Access Compliance Report

Public Rights-of-Way

(Curb Ramps)

Intersection ID: 23309	Main Street: BRIDGEWOOD_LN	Cross Street: CARMEL_RD	Location: S
ADA ID: B18E577494A1	Ramp Type: PerpDiag	Initial Pass/Fail: Pass	Overall Compliance: No
Severity Score: 30			
Codes/Mitigation Info/Possible Solution		Field Measurements/Component Compliance

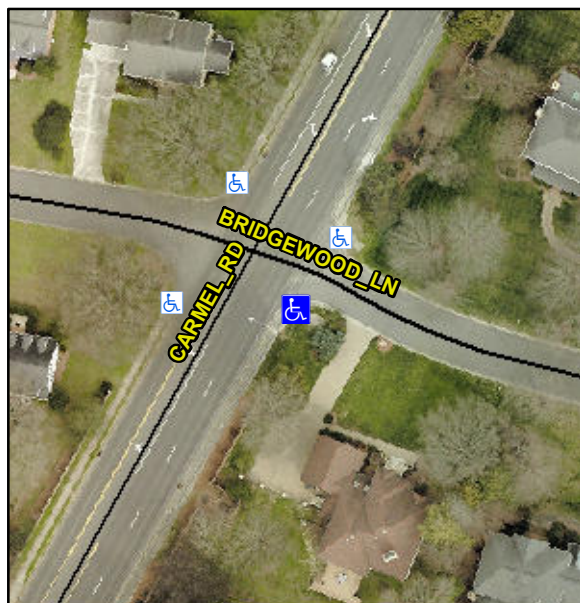
Not Found, R304.2.1, R304.2.2-Perp, R304.3.2-Para, R304.5.3, R304.2.3, R305.1.4, R305.2, R302.7.2

Compliance	Description	Data	Compliance	Description	Data
N/A	Ramp Length (in)	96.0	Yes	Ramp Slope (%)	5.8
Yes	Ramp Width (in)	48.0	Yes	Ramp XSlope (%)	1.4
N/A	Flare Type LT	Sloped	N/A	Flare Type RT	N/A
N/A	Flare Slope LT (%)	10.5	Yes	Flare Slope RT (%)	6.8
N/A	Flare Traversable LT?	Yes	N/A	Flare Traversable RT?	Yes
No	Landing Length (in)	N/A	Yes	DWS Provided?	Yes
No	Landing Width (in)	N/A	Yes	DWS Contrast?	Yes
No	Landing Slope (%)	N/A	Yes	DWS Length (in)	24.0
No	Landing X Slope (%)	N/A	No	DWS Full Width?	No
N/A	Landing Curb? (Y/N)	No	No	DWS Offset (in)	7.0
N/A	Shared Landing?	N/A			
Yes	Gutter Ponding?	No	Yes	Gutter Slope (%)	4.9
No	Gutter Lip Ht (in)	1.5	Yes	Gutter X Slope (%)	1.1
N/A	Painted X Walk1?	No	N/A	Painted X Walk2?	No
	X Walk 1 Direction	To NW		X Walk 2 Direction	To NE
N/A	X Walk 1 Width (in)	N/A	N/A	X Walk 2 Width (in)	N/A
	X Walk 1 Slope (%)	2.3		X Walk 2 Slope (%)	2.3
	X Walk 1 X Slope (%)	0.2		X Walk 2 X Slope (%)	4.1

N/A	Ramp inside XWalk1?	N/A	N/A	Ramp inside XWalk2?	N/A
	Road Slope (%)	0.2	N/A	Clear Space?	Yes
	Road X Slope (%)	3.5	N/A	Clear Space to XWalk (in)	N/A
Yes	Any Obstructions?	No	Yes	Storm Grate/Utility Hazard?	No
	Obstruction Type			Storm Grate/Utility Type	
		N/A			N/A
			Yes	Surface Condition? (G/P)	Good

Remove & Replace Curb Ramp With Two New Directional Ramps or Equivalent.
